Service Bulletin

Release of DX-D 100 / 100 Wireless System Version 4.2

Release date: 09-2013 DX-D 100 - SB No. 29; DX-D 100 Wireless - SB No. 26

Figure 1

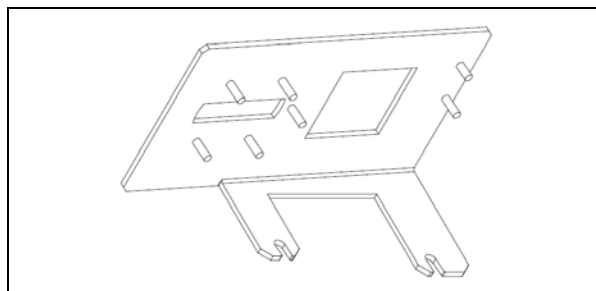
The cord reel cannot be mounted in the DX-D 100 / 100 Wireless without cutting off the plug.

Design of metal plate did not allow passing the plug though the provided opening.

Figure 2

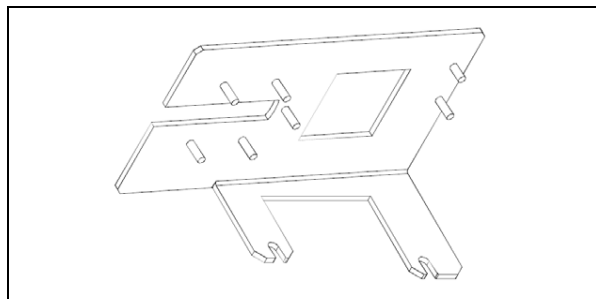
Design change of the metal plate (a slit open to one side instead of a hole) to allow installation of the cord reel without the need to cut off the plug.
